SERVICE BULLETIN

| SERVICE BULLETIN | | No.: MSB-00E00-003 | |
| Subject: YEAR MODEL CHANGES FOR 2001 L200 | | | |

This Service Bulletin informs you of the year model changes for the 2001 L200

OUTLINE OF CHANGES

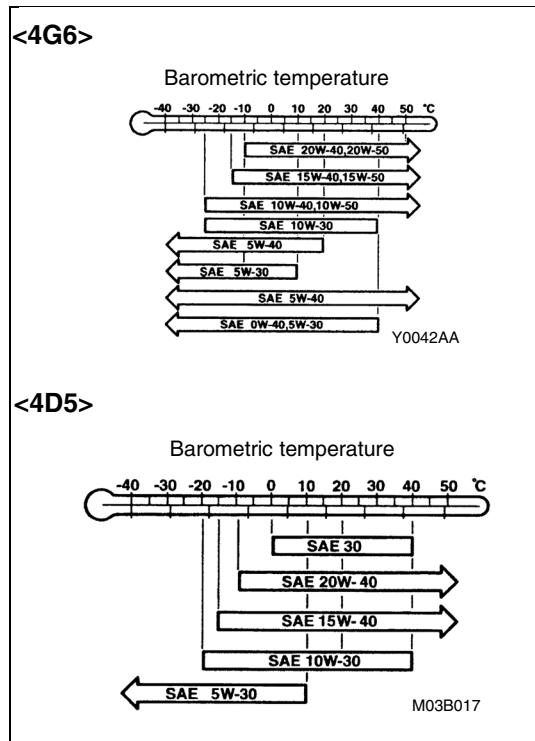
- A quality of the engine oil has been changed.

specified engine oil (ACEA and API classification):

<4G6> ACEA A1, A2, A3/API SG or higher

<4D5> ACEA B1, B2, B3, B4/API CD or higher

KEYLESS ENTRY SYSTEM REMOVAL AND INSTALLATION

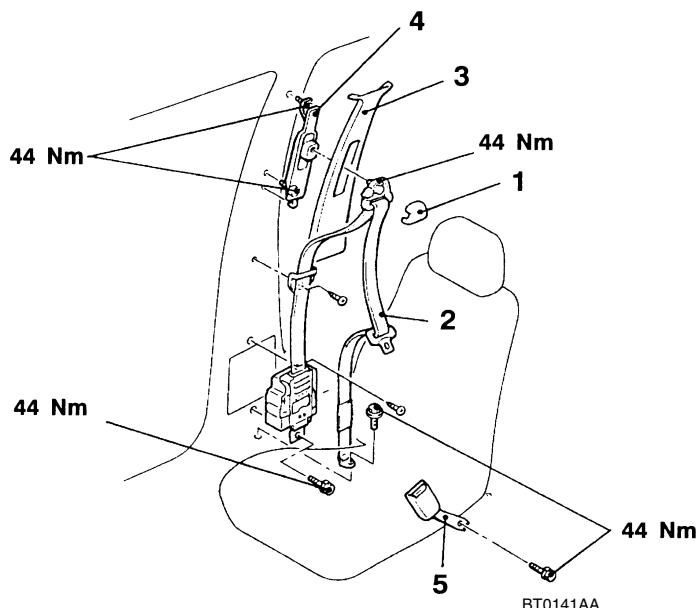
The following service procedures have been added due to the introduction of the keyless entry system as an optional equipment <GLS>.

Keyless entry receiver-ECU removal steps

- Glove box assembly (Refer to GROUP 52A*.)
- 1. Keyless entry receiver-ECU

ETACS-ECU removal

2. ETACS-ECU

**HIGH-MOUNTED STOP LAMP
REMOVAL AND INSTALLATION**

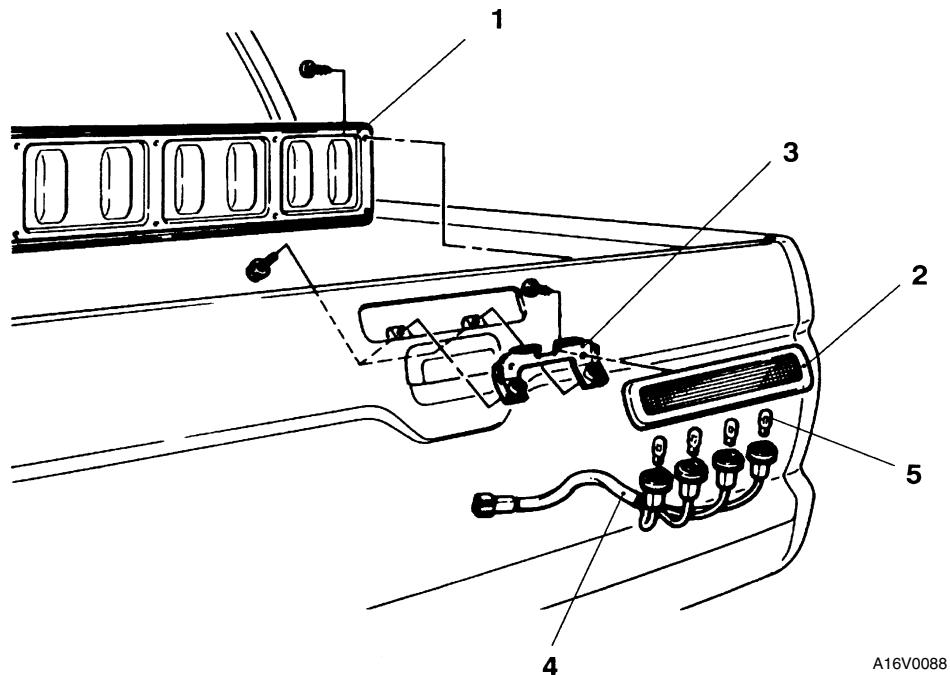
- The following procedure has been added due to the addition of the high-stop lamp <4WD>.

Removal steps

1. Rear gate panel
2. High mounted stop lamp
3. Lamp bracket
4. Bulb socket assembly
5. Bulb
